# UNITED STATES PATENT AND TRADEMARK OFFICE

10/565,102

<b>Office Action Summary</b>	<b>Application No.</b> 10/565,102	<b>Applicant(s)</b> INAGAKI, TOSHIYUKI	
	<b>Examiner</b> Raymond Alejandro	<b>Art Unit</b> 1795

## **DETAILED ACTION**

**FIG .31**

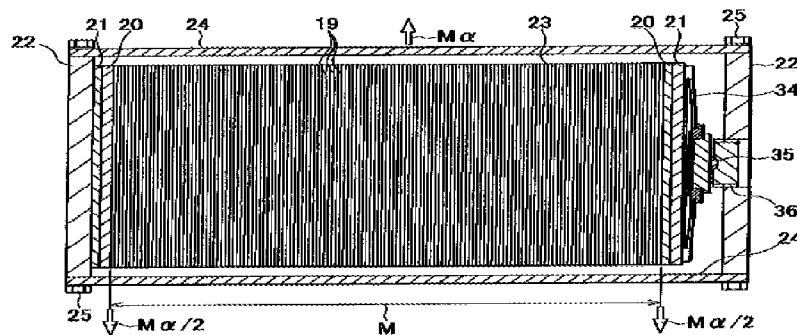
**FIGURE 31** of the AAPA clearly illustrates a fuel cell assembly including multiple modules or a plurality of stacked cells; either elements 21, or 20 in combination with the upper and lower element (right below and above reference number 25) do form a module frame surrounding or enclosing the cell assembly and extending in a cell stacking direction (See

FIGURE 31). Spring 34 can act as the external restrainer member located between any one of elements 21 or 20 and the swing portion 35 and/or an adjusting screw 36 which can serve as the external member. *Therefore, the fuel cell assembly arrangement of the AAPA reads on applicant's invention of claim 24 as instantly recited.*

As shown in **FIGURE 31**, it is apparent that elements 20, 21 are capable of leaving the stacked cells unrestrained if necessary. Since the cells are stacked to one another, it can be said that they are adhered (in contact with) to each other.

As illustrated in FIGURE 31, note that the stacked cells are disposed in series in the stacking direction; that there is disclosed a spring feature including a spring 34 which is disposed on an end of a cell stack in the cell stack direction, a swing portion 35 and an adjusting screw 36 (0007 & FIGURE 31). There are also the upper and lower elements (right below and above reference number 25) which represent the wall perpendicular to the cell stacking direction and they two have the ability of being displaceable if necessary. Note that the term displaceable only requires the ability of being displaced.

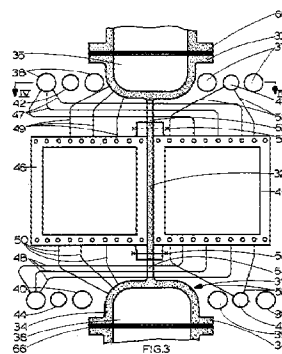
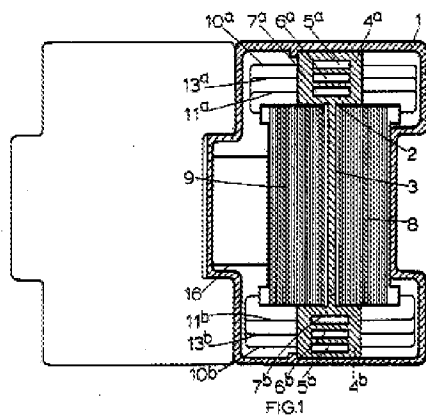
Enlarged section of FIGURE 31 illustrates the presence of a space provided therebetween which can assist in relieving thermal expansion.

The AAPA shows that gaskets 32 and adhesive seals 33 are provided in order to seal channels containing a groove (FIGURE 30 and 0005).

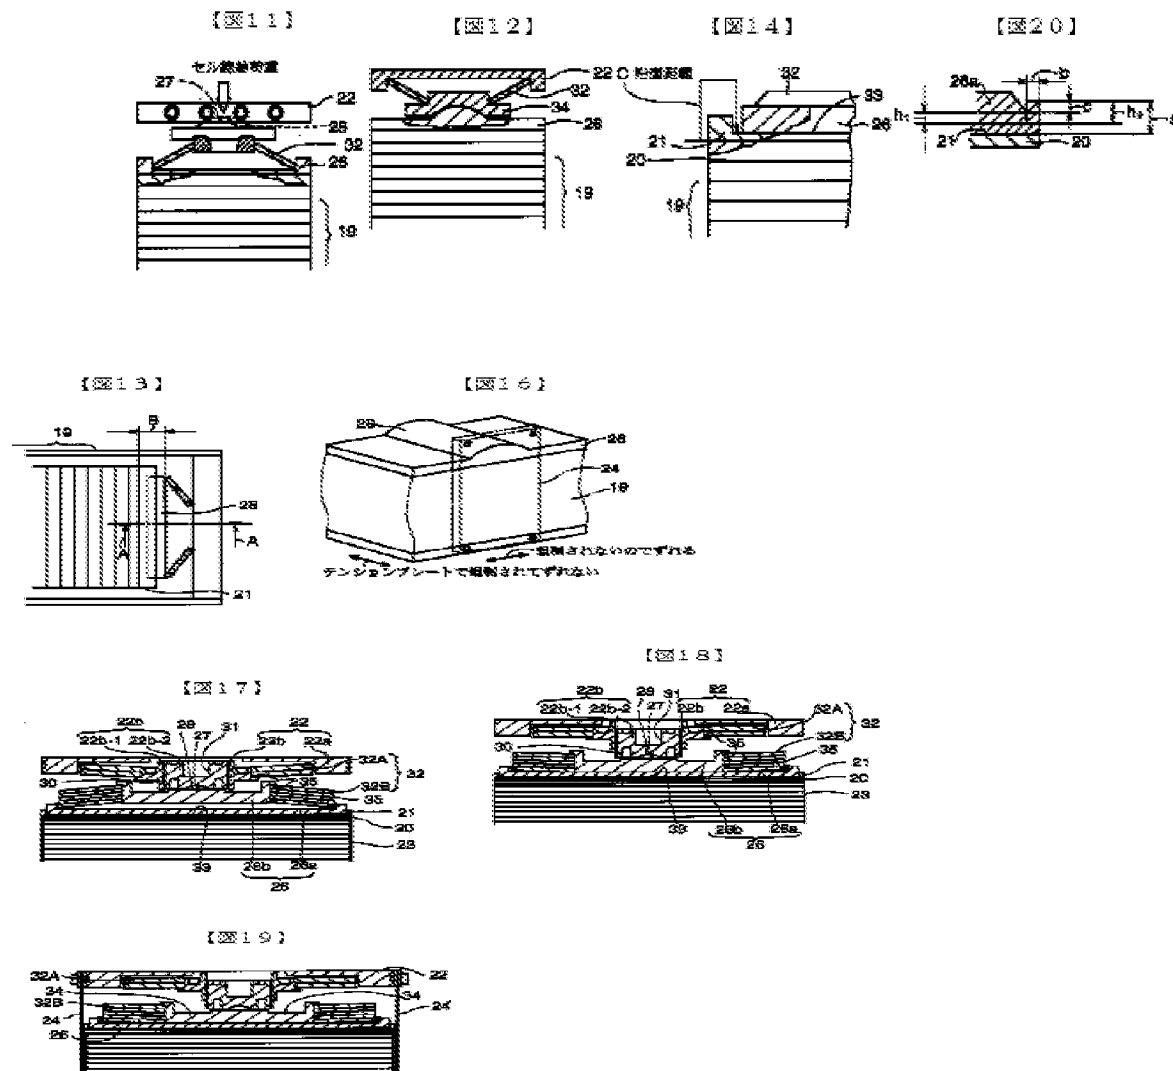
**FIGURES 11-14 and 16-20** of JP'291 clearly depicts a fuel cell module unit containing a number of fuel cell blocks (module) including an external member, an external restraining member; and a module frame wherein the external restrainer member is placed between the fuel cell module frame and the external member. The module frame includes a wall which surrounds the fuel cell blocks and extends in a cell stacking direction (FIGURES 11-14 and 16-20).

Fig. 1

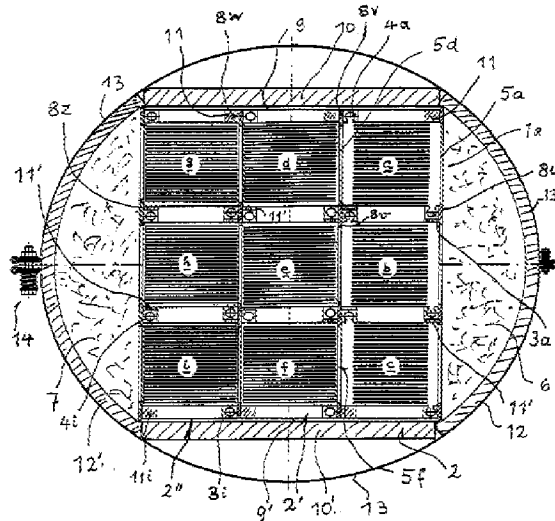
**FIGURES 1 and 2** of DE'111 clearly depicts a fuel cell module unit containing a number of fuel cell blocks (module) including an external member, an external restraining member; and a module frame wherein the external restrainer member is placed between the fuel cell module frame and the external member. The module frame includes a wall which surrounds the fuel cell blocks and extends in a cell stacking direction (FIGURES 1 & 2).
